Bel Pre Elementary School Modernization, Mandatory Referral MR2012008

RECOMMENDATION: Staff recommends approval of the proposed mandatory referral with the following comments:

Figure 2: Proposed site plan

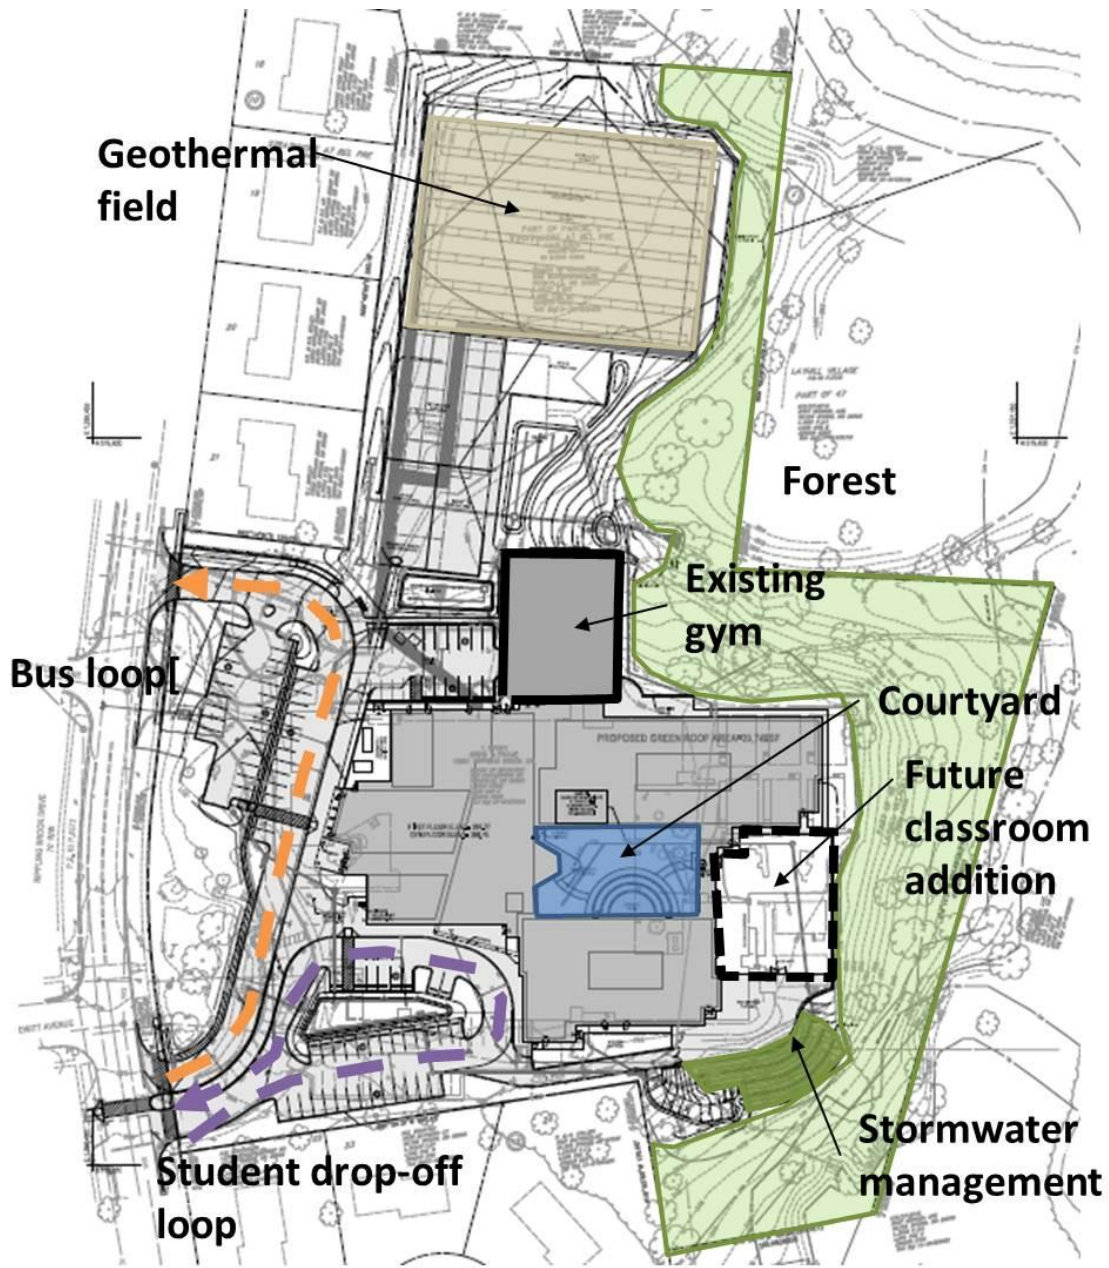
1. The proposed development must comply with the Final Forest Conservation Plan.
2. Any mandatory referral submission for future improvements at the subject school must include a traffic study if those improvements will increase the school's core capacity beyond 740 students.
3. Provide additional screening between the front parking facility and the sidewalk.

The proposed front parking facility does not meet the 40-foot front setback requirements of the R-150 Zone; the proposed plan provides a 28' setback. Ten parking spaces would have to be removed in order

to meet this development standard. Since the site is constrained by environmental features and it is not feasible to move the parking facility back to provide the full setback, staff is recommending additional planting to provide screening for the parking facility, in addition to the landscaping proposed by the Applicant.
